Serial No. 10/554,177 (BR210-66910/2)
Response to Office Action mailed May 13, 2009

Amendment to the Drawings

FIG. 13

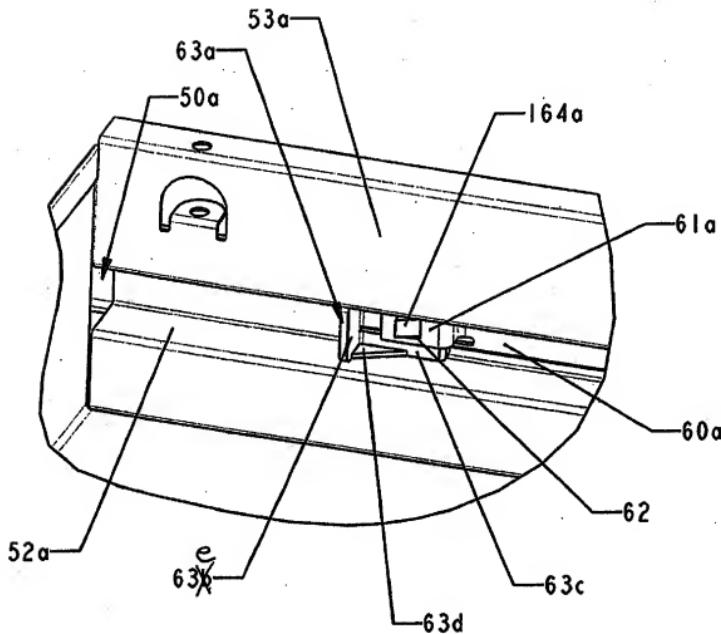
The attached sheet of drawing includes a change to FIG. 13. This sheet replaces the original sheet including FIG. 13. In FIG. 13, reference numeral 63b has been changed to 63e.

Paragraph [0061] of the specification and FIG. 13 of the drawings have been amended to change the reference numeral associated with the flange from 63b to 63e. This change has been made because reference numeral 63b is already being used in association with the clip shown in FIG. 14.
